**Insubstantial Changes to the Approved Plans dated 4/11/17**

Subsequent to the issuance of our Approved Plans, there have been minor changes to the plans. We believe these changes qualify as insubstantial. The modifications are listed below.

**Revised Plans dated 11/2/17: L-100 Image illustrating Fire Access Surfacing**

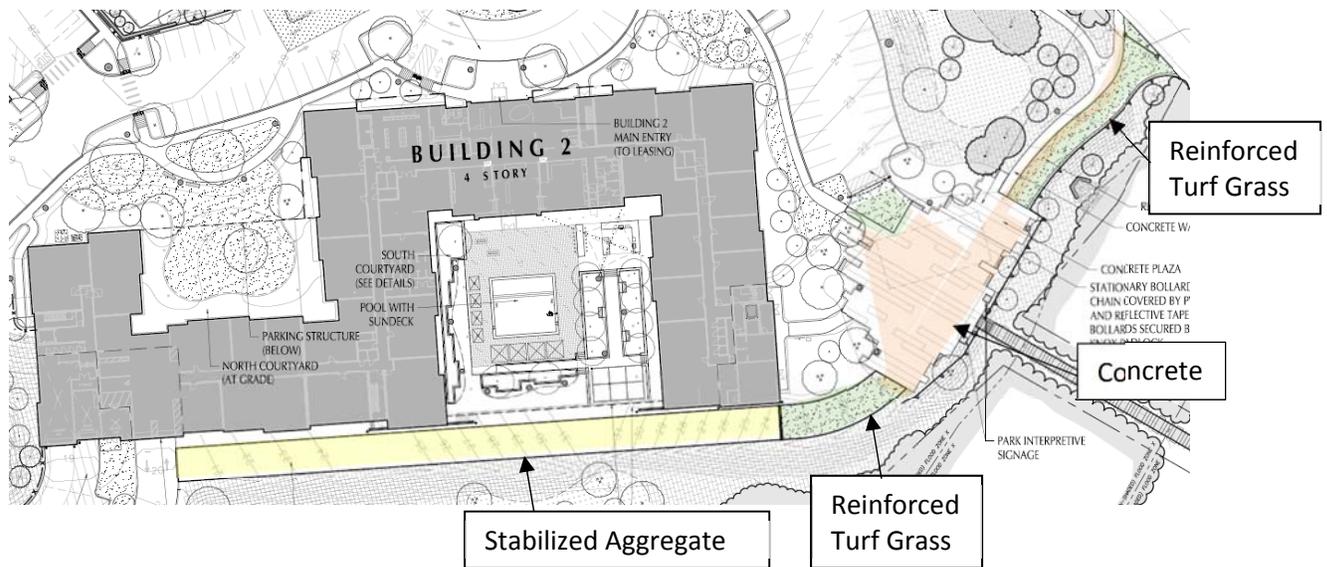
1) Sheet C2 & L-100: We are proposing to replace a portion of the reinforced turf grass (RTG) with stabilized aggregate. The stabilized aggregate detail is shown on Sheet D-3, Detail #5 in the plans. The reason for this change is that the RTG specifications do not meet the slope requirements of the fire access road (RTG has a maximum slope of 5%, and the fire access road slope is ~8% in the area behind Building 2). We're proposing stabilized aggregate because it has a higher slope limit, retains the pervious characteristics required by our drainage report, and is commonly and successfully used for fire access roads. We've communicated this change with Lt. Chris DiNapoli of the Hingham Fire Department.

Below is an annotated image of Sheet L-100 to illustrate the proposed access road surfacing. The yellow area represents approximately 7,200 SF of stabilized aggregate replacing RTG; This area is the only change to the access road surfacing materials. We've also included an image of the stabilized aggregate installation.

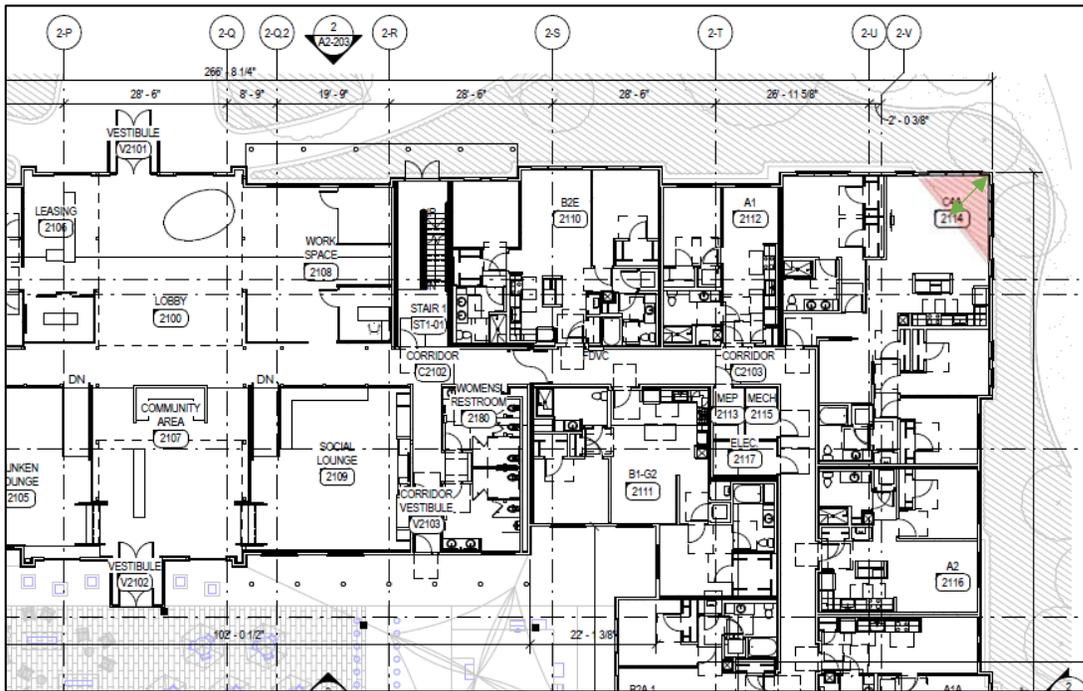
2) Multiple Sheets including Building 2 Floor Plans (sheet A2-100 – A2-104): In order to coordinate unit layouts with the building envelope and structure, the northeast corner of Building 2 has been squared off. This resulted in the building edge being pushed ~17' (see green arrow below) to the east, or an increase of 468 SF of buildable area above grade (117 SF \* 4 floors = 468 SF). This modification increases the FAR by 1.47%, from .68 FAR in the Approved Plans to .69 FAR in the revised plans, but does not affect setbacks, height or any other dimensional waivers. This change is reflected on all site plans and floor plans. Below is a graphic of sheet A2-101 illustrating this change highlighted in red.

Approved Plans dated 4/11/17: B1 Garage

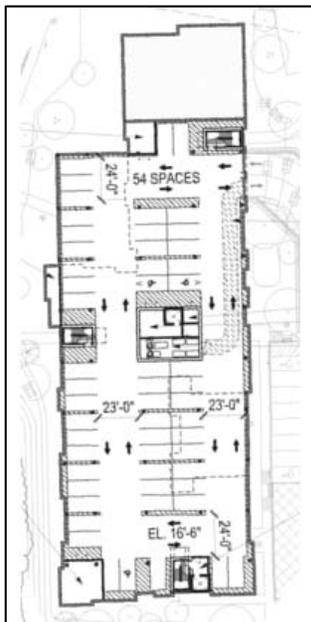
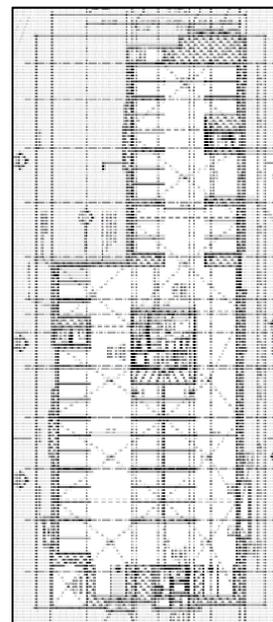
3) Building 1 Garage Plan Sheet A1-100: In order to optimize constructability, we have redesigned Building 1's Garage. The approved aisle widths have been retained (all aisles are wider than or equal to 23'). Please see the images below showing Building 1's Garage plan from the Approved Plans compared to the Revised Plans.
